P1394b Simulation Taskforce July Report

Jerry Hauck(MDI)
&
John Smolka (TI)

Figure 11-3 vs send_speed()

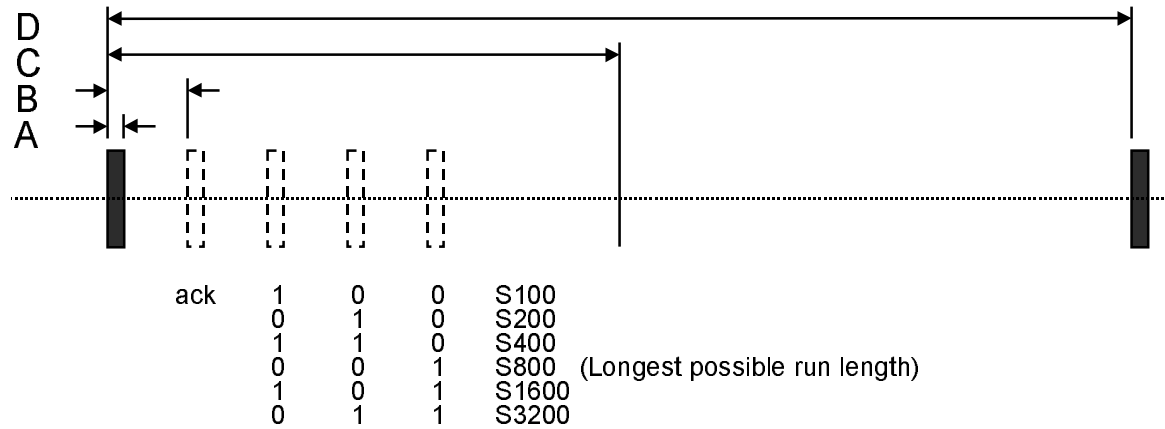
Figure 11-3	send_speed()	Comment
A	666.67 us	TONE_DURATION = 666.67 us	✓
B	2.67 ms	(TONE_DURATION + SPEEDTONE_BIT_INTERVAL) = (5*TONE_DURATION) = 3.33 ms	x
C	21.33 ms	??	Why specified?
D	42.67 ms	[TONE_DURATION + 4 * (SPEEDTONE_BIT_INTERVAL + TONE_DURATION)] + [DISCONNECTED_TONE_INTERVAL - 4*(SPEEDTONE_BIT_INTERVAL + TONE_DURATION)] = [DISCONNECTED_TONE_INTERVAL + TONE_DURATION] = 43.33 ms	x
